**RE: Planning Commission Advisory Report**  
**Ordinance No.: 2022-302 Application for: Halsema Villas PUD**

**REPORT OF THE PLANNING AND DEVELOPMENT DEPARTMENT FOR**  
**APPLICATION FOR REZONING ORDINANCE 2022-0302 TO**  
**PLANNED UNIT DEVELOPMENT**

**SUBJECT:** Transportation Memorandum 2022-0302

**PROJECT SUMMARY**

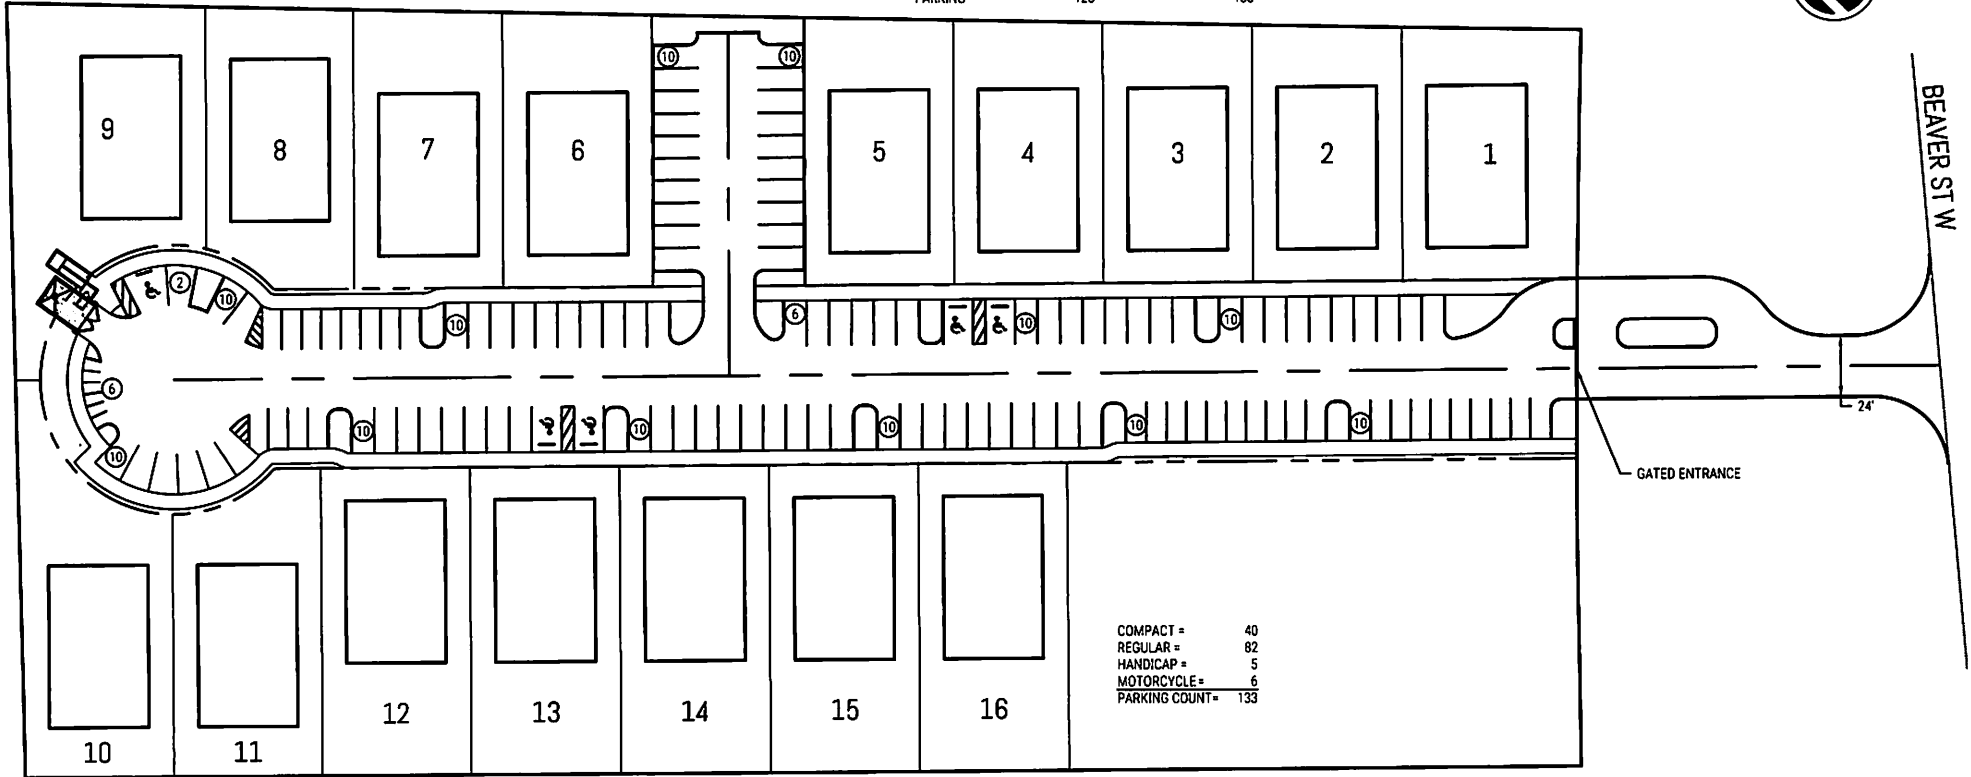
**The treatment of pedestrian ways:** The proposed PUD request to deviate from the code regarding sidewalk width and requesting all sidewalks to be 4 feet in width with placement and interconnectivity approved as shown on the site plan. Per Transportation Memorandum dated May 3, 2022 and conditioned for this PUD: *Provide sidewalks per Section 654.133 of the Code of Subdivision Regulations. ADA compliant sidewalk shall be required on all public ROW frontages, or as otherwise approved by the COJ Bicycle Pedestrian Coordinator.* This is a safety issue for pedestrians. Large trucks can hangover the sidewalk prohibiting those with disabilities.

- The PUD written Description states “Access will be provided as shown on the PUD Site Plan; provided, however, that access from Marisco Way is permitted without the need for a PUD modification.” If the PUD will access Marisco Way, a traffic study shall be provided at Civil Site Plan Review. Prior to the commencement of the traffic study, the traffic professional shall conduct a methodology meeting to determine the limits of the study. The methodology meeting shall include the Chief of the Traffic Engineering Division (currently Chris LeDew CLeDew@coj.net), the Chief of the Transportation Division (currently Laurie Santana LSantana@coj.net) and the traffic reviewer from Development Services (currently John Kolczynski JohnFK@coj.net).

- Beaver Street W is an FDOT right of way. Permitting for access to Beaver Street W shall be through FDOT.
- ADA compliant sidewalk shall be required on all public ROW frontages, or as otherwise approved by the COJ Bicycle Pedestrian Coordinator.

The subject site will be serviced by JEA for city water and sewer. Additionally, in a memo provided by JEA dated April 27, 2022, JEA has objections to the proposed project layout. The right of way provided in the site plan with striped parking is problematic from a utility standpoint. JEA water and sewer utilities including services should not be placed under parking areas. There is no space within the proposed right of way for all water and sewer mains, services and fire hydrants. Site plan should be modified to include utility corridors and landscape islands should be modified to align with water and sewer service locations. This may affect the number of parking spaces. Proper setbacks from structures and landscape/hardscape features should be provided to any proposed utility corridors per JEA standards. Utility corridors should be provided with either expanded right-of-ways or land tracts under ownership of the homeowners association. Utility easements across individual lots are typically not allowed.

As previously mentioned the proposed PUD request to deviate from the code regarding sidewalk with and requesting all sidewalks to be 4 feet in width with placement and interconnectivity approved as shown on the site plan. Per Transportation Memorandum dated May 3, 2022 and conditioned for this PUD: *Provide sidewalks per Section 654.133 of the Code of Subdivision Regulations. ADA compliant sidewalk shall be required on all public ROW frontages, or as otherwise approved by the COJ Bicycle Pedestrian Coordinator.* This is a safety issue for pedestrians. Large trucks can hangover the sidewalk prohibiting those with disabilities.

- The PUD written Description states “Access will be provided as shown on the PUD Site Plan; provided, however, that access from Marisco Way is permitted without the need for a PUD modification.” If the PUD will access Marisco Way, a traffic study shall be provided at Civil Site Plan Review. Prior to the commencement of the traffic study, the traffic professional shall conduct a methodology meeting to determine the limits of the study. The methodology meeting shall include the Chief of the Traffic Engineering Division (currently Chris LeDew CLeDew@coj.net), the Chief of the Transportation Division (currently Laurie Santana LSantana@coj.net) and the traffic reviewer from Development Services (currently John Kolczynski JohnFK@coj.net).

- Beaver Street West is an FDOT right of way. Permitting for access to Beaver Street West shall be through FDOT.
- ADA compliant sidewalk shall be required on all public ROW frontages, or as otherwise approved by the COJ Bicycle Pedestrian Coordinator.

- Deviation from code regarding sidewalk width is denied. Provide sidewalks per Section 654.133 of the Code of Subdivision Regulations.
